Evaluation of Turkey Point Nuclear Plant Units 3 and 4 Offsite Dose Calculation Manual, Revision 4

**Docket No. 50-250, Facility License No. DPR-31 &
Docket No. 50-251, Facility License No. DPR-41**

Published September 1995

**Prepared for the
Division of Radiation Safety and Safeguards
Office of Nuclear Reactor Regulations
U.S. Nuclear Regulatory Commission
Washington, D.C. 20555
FIN E2084**

Figure 1. Liquid effluent release routes at TPN.

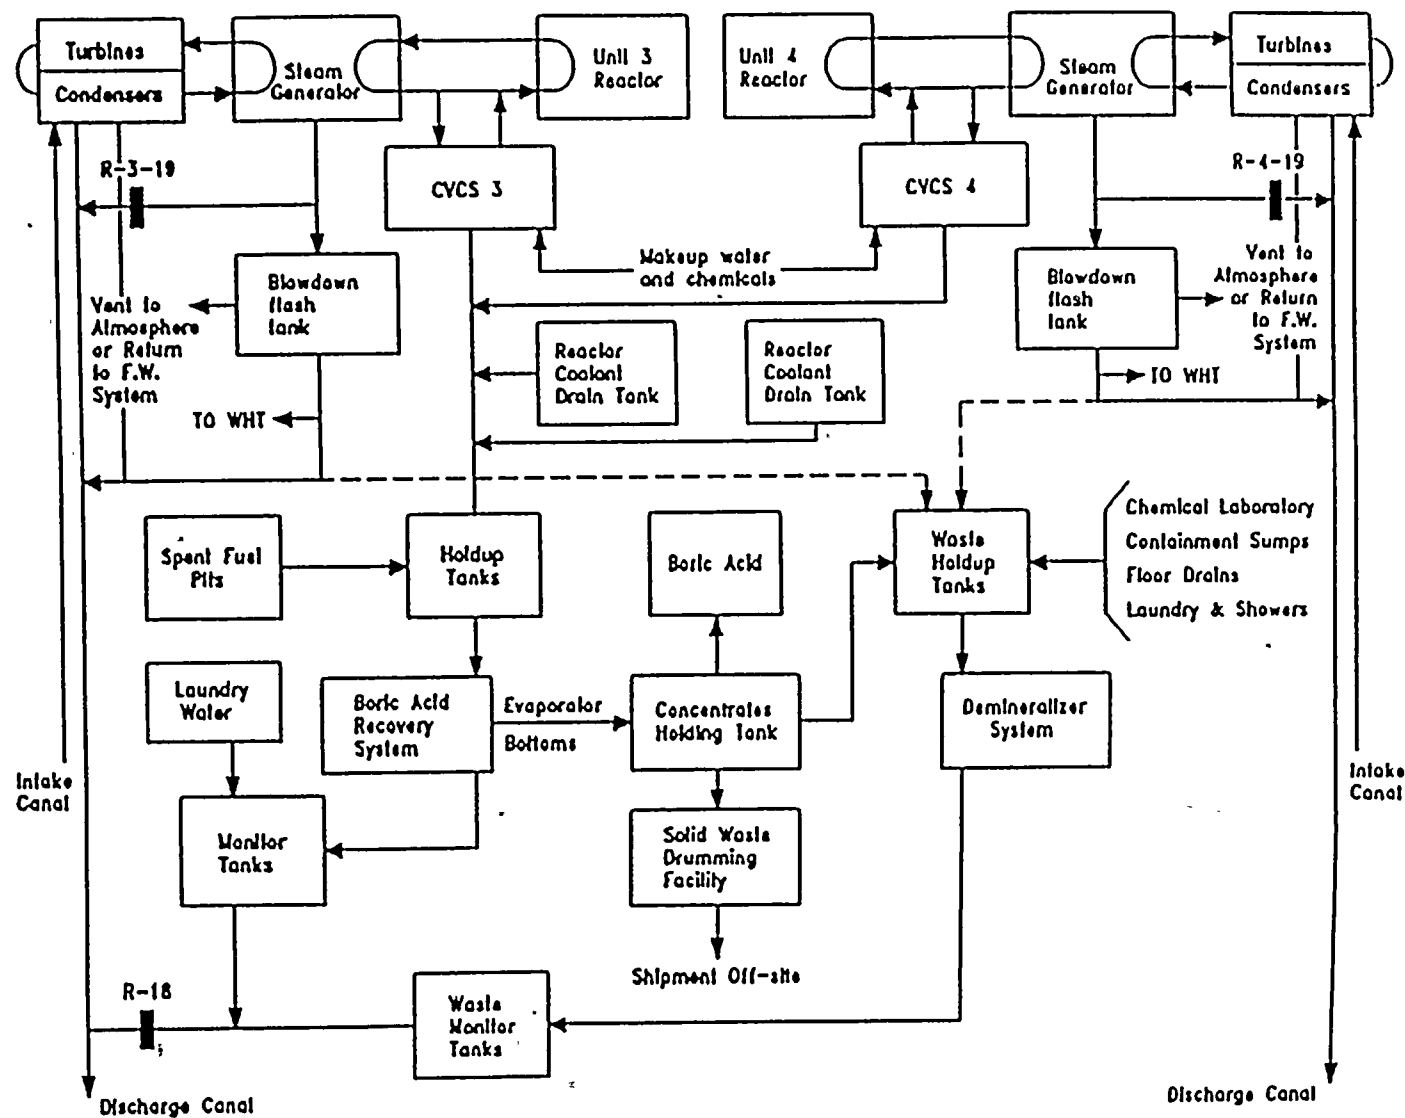
Radioactive liquid effluent releases from TPN Units 3 and 4 are discharged through three pathways: steam generator blowdown from each unit and a common radwaste monitor tank. These three pathways are monitored with alarm and termination monitors. Radioactive materials in liquid effluents from TPN are diluted by condenser cooling water from fossil Units 1 and 2 and from nuclear Units 3 and 4 in the condenser cooling water mixing basin. Water in the basin flows into an onsite closed cooling canal system and does not actually leave the site in a surface discharge. The total condenser cooling water flow from all the operating condenser cooling water pumps at the four units is assumed for dilution, and the restricted area boundary is assumed to be at the end of the condenser cooling water mixing basin at the entry of the cooling canal system. Figure 1 shows a schematic diagram of the TPN radioactive liquid effluent pathways. However, the condenser cooling water mixing basin and the storm drains are not shown in the radioactive liquid effluent pathways diagram.

The ODCM contains three diagrams in the main body of the document and two diagrams in Appendix E. The first diagram in the main body clearly shows the liquid effluent pathways with the omission of the condenser cooling water mixing basin. The storm drains are not shown in the radioactive liquid effluent pathways diagram. These pathways should be included in the diagrams. The second diagram in the ODCM shows the gaseous effluent pathways. The third diagram adequately shows the locations at which doses due to airborne effluents from TPN are calculated. Appendix E includes two adequate diagrams depicting the site and plant areas.

Figure 2. Gaseous effluent release routes at TPN.

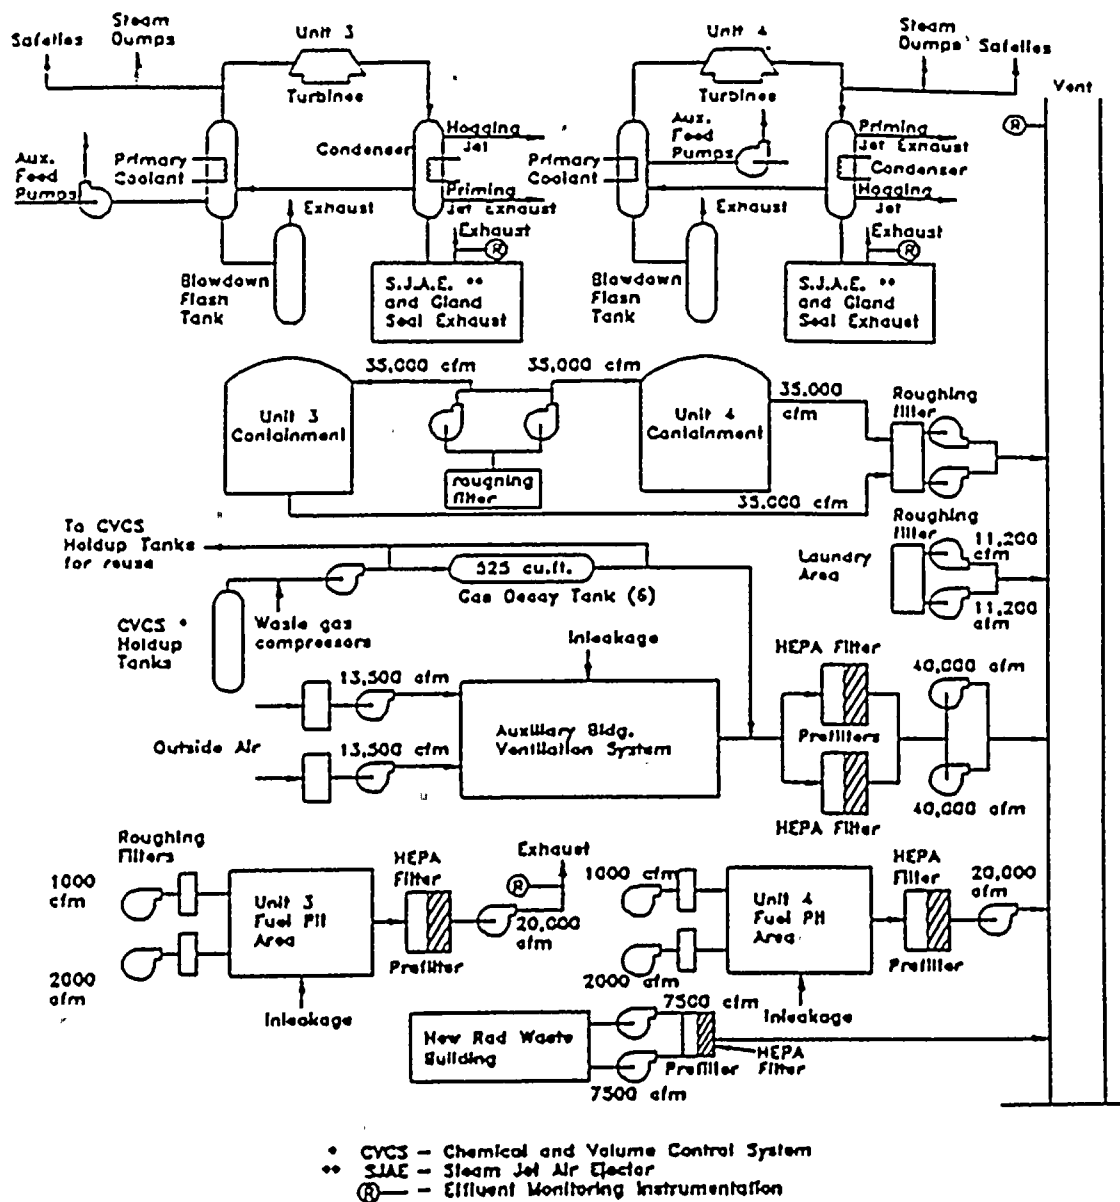
Airborne releases from these radioactive gaseous effluent release points are considered as a mixed-mode release from a single location for calculating doses and dose rates. Figure 2 shows a schematic diagram of the TPN Units 3 and 4 radioactive gaseous effluent pathways.

The height of the plant vent stack, the release point of the air ejectors, and the Unit 3 spent fuel vent should be specified in the ODCM to support dispersion modalities used in the calculation of air doses.

1. The filtration system associated with the containment buildings, the auxiliary building, the Unit 4 spent fuel pit, the radwaste building, and the laundry area should be described in the ODCM.
2. Section 3.2.1 of the ODCM indicates that "Other steam losses concurrent with primary to secondary leakage are unmonitored and their effluents must be accounted for." The ODCM should provide the methodology used to account for these releases, or the reasons for omitting it should be included in the ODCM.
